**Ivas Environmental
Environmental Sciences
Wetlands and Planning Services**

**City of Boston Conservation Commission
Boston City Hall
1 City Hall Square
Boston MA 02201**

RE: MA DEP File #: NE - 006-1816, 155 Porter Street, East Boston

This letter covers the attached package of information provided to the City of Boston Conservation Commission. It is written as a response to Mr. Moreno's comments of 03 Nov 21 regarding the proposed project at 155 Porter Street.

1 BUILDING SECTION
A-302 3/32" = 1'-0"

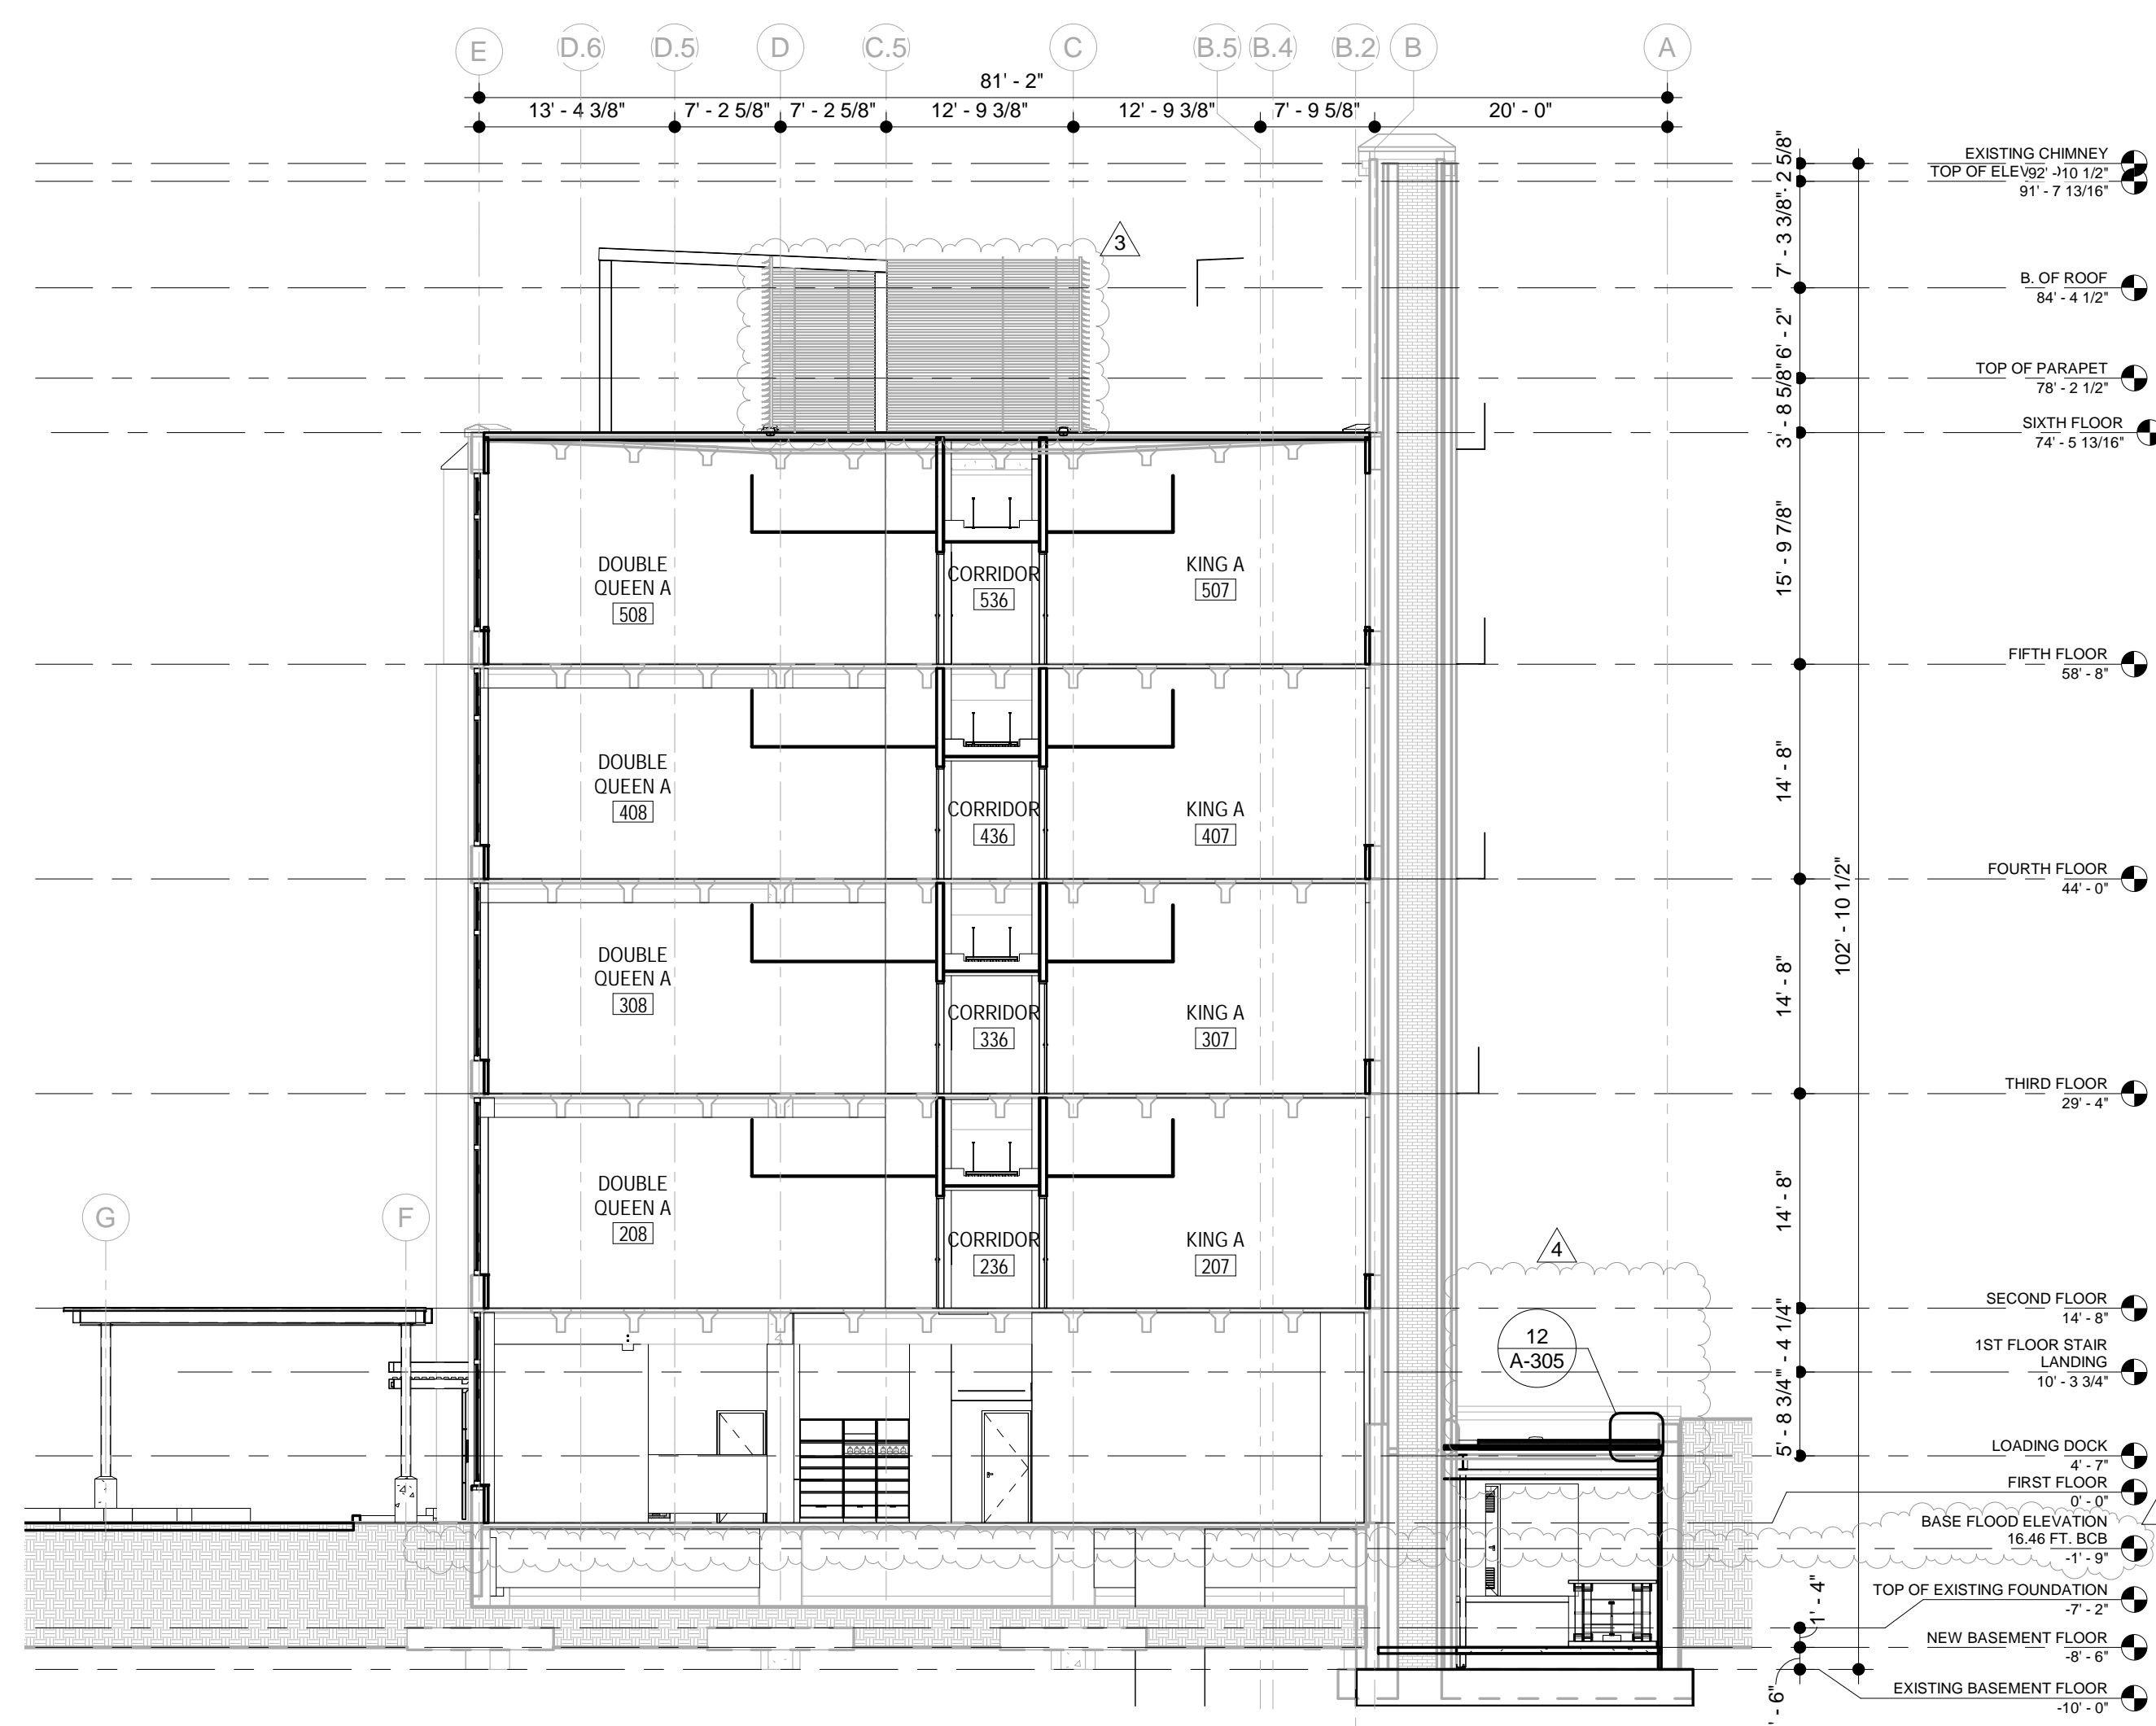
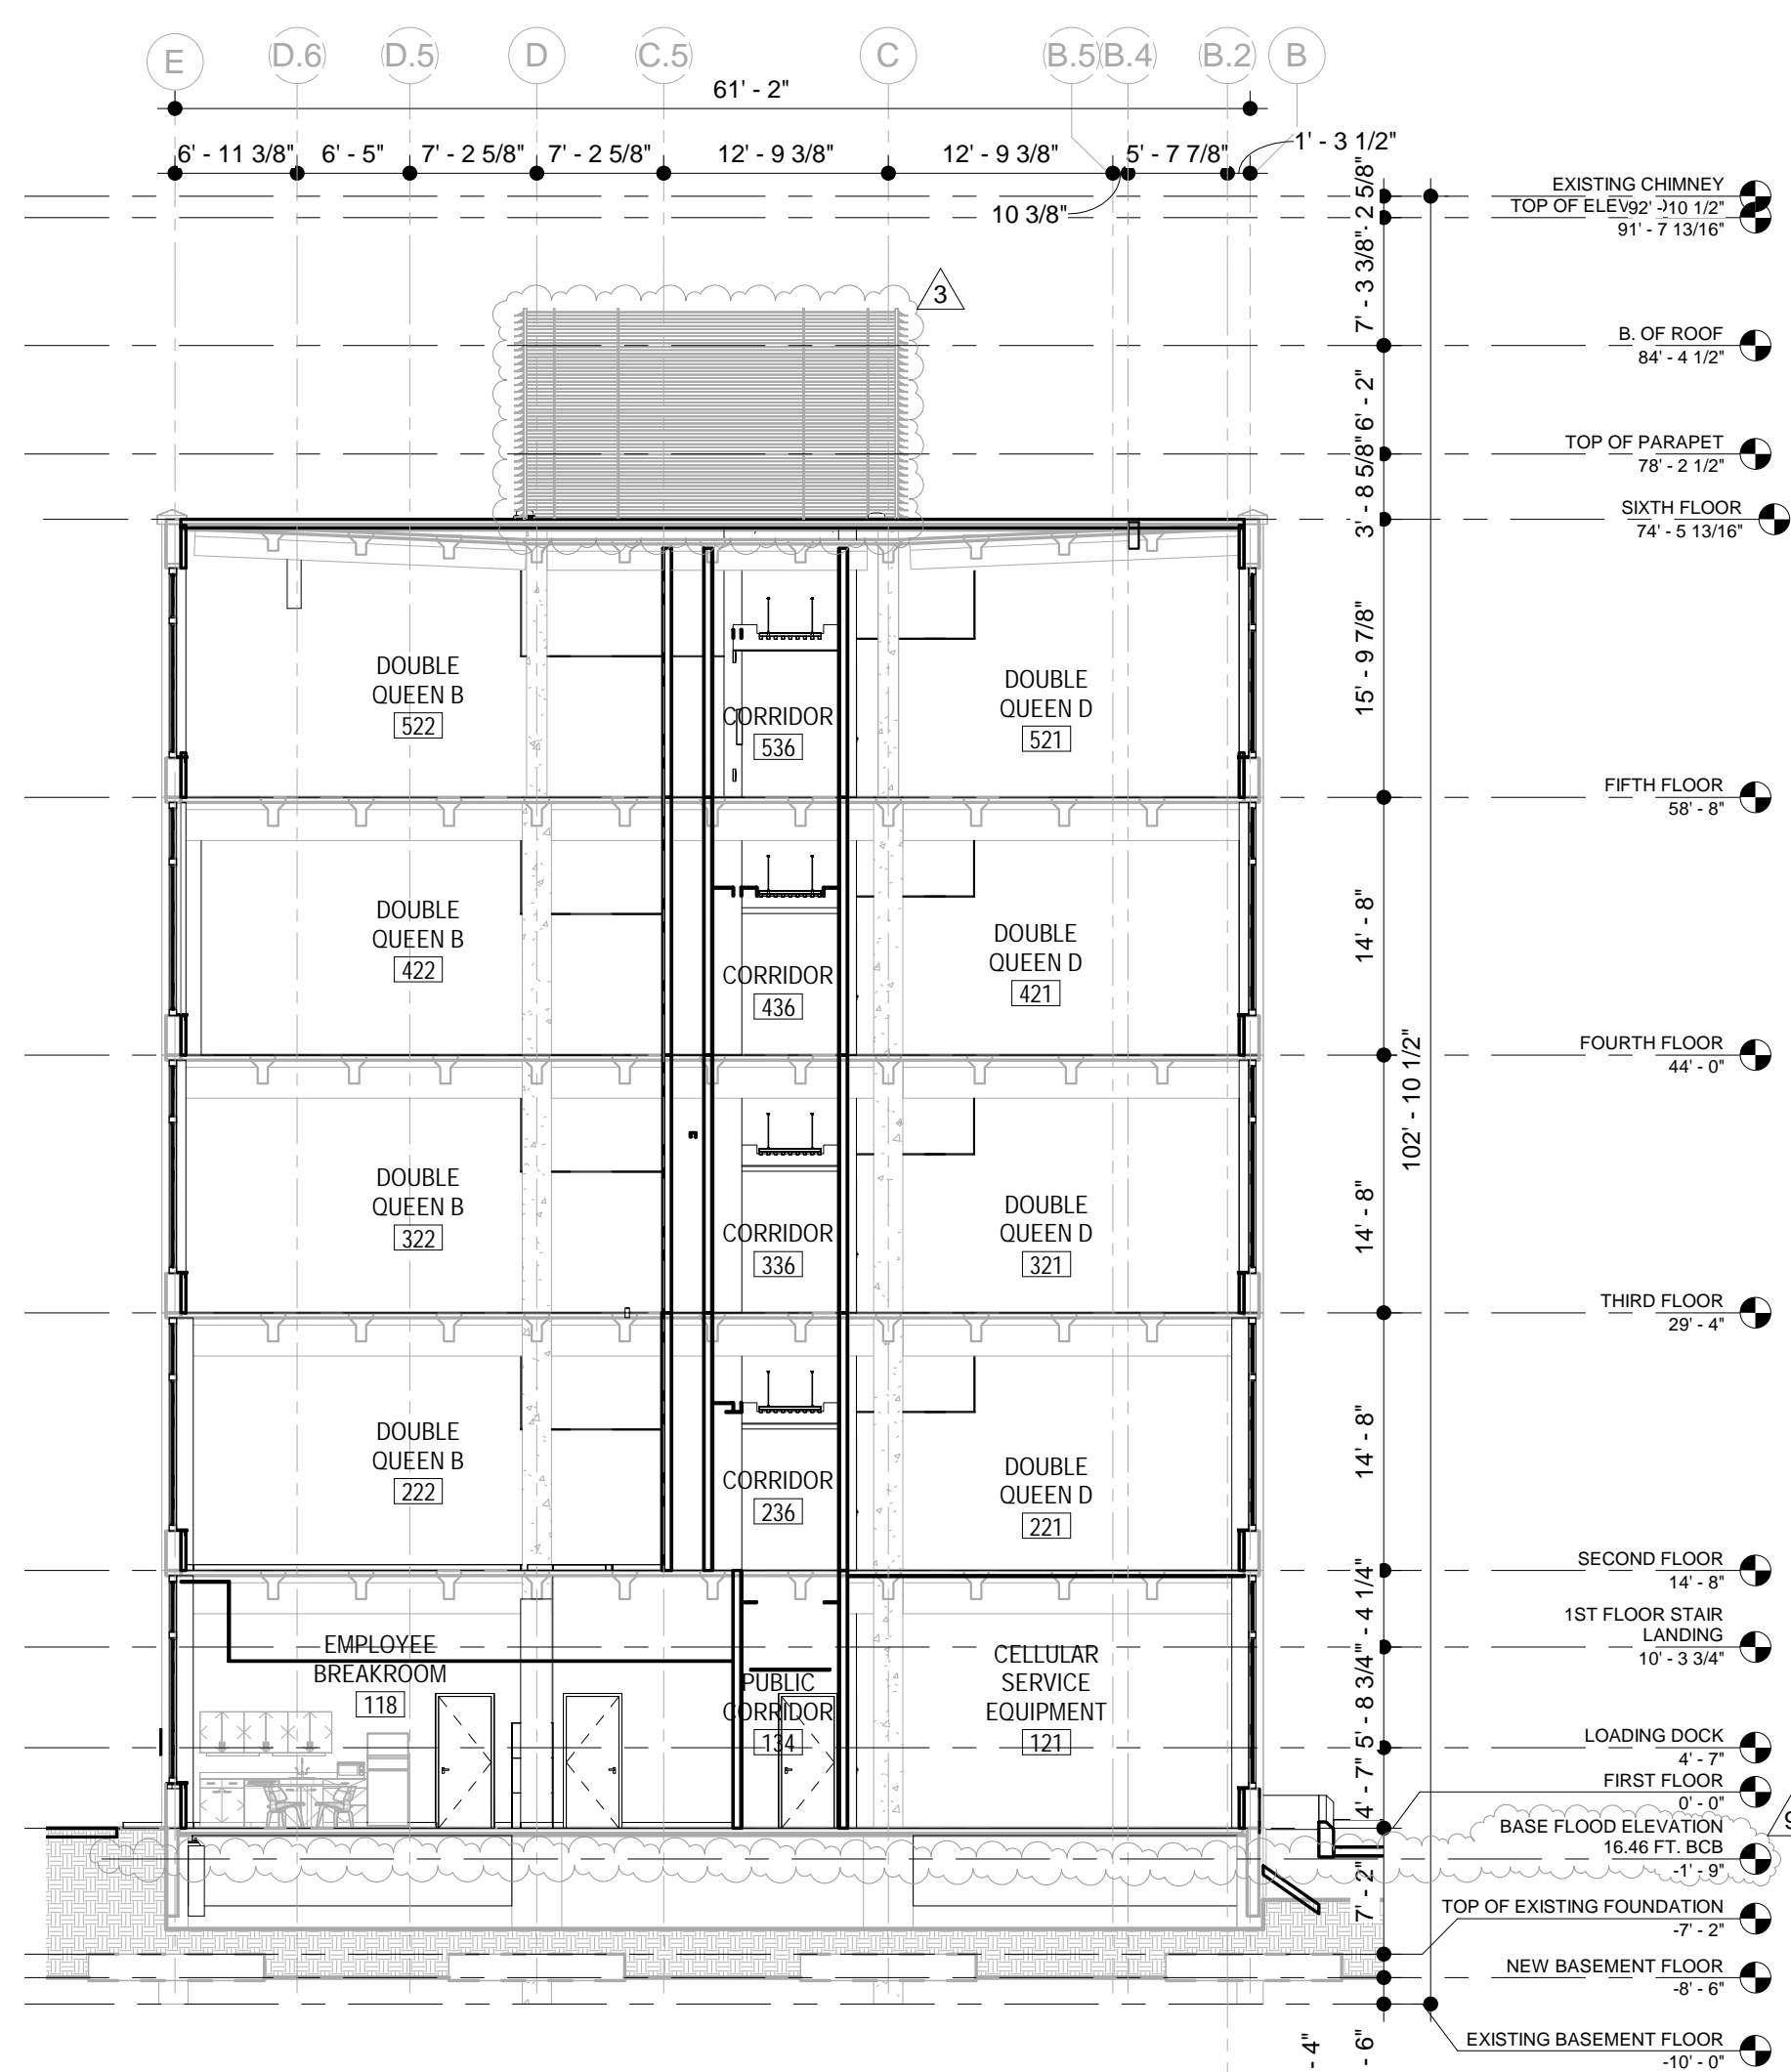
8. Please also include the base flood elevation line on the building section plans.

The base flood elevation has been provided on the building section plans attached.
